Manual Supplement

Manual Title: 116 Users
Part Number: 2538688
Print Date: July 2006
Revision/Date:

Supplement Issue: **3**
Issue Date: 9/06
Page Count: 3

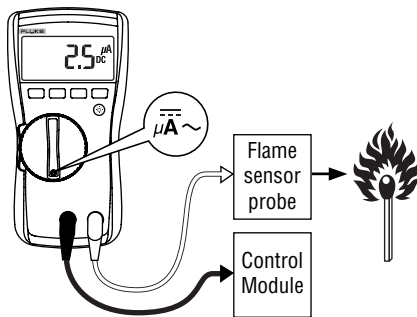
On page 13, replace the figure with the following:
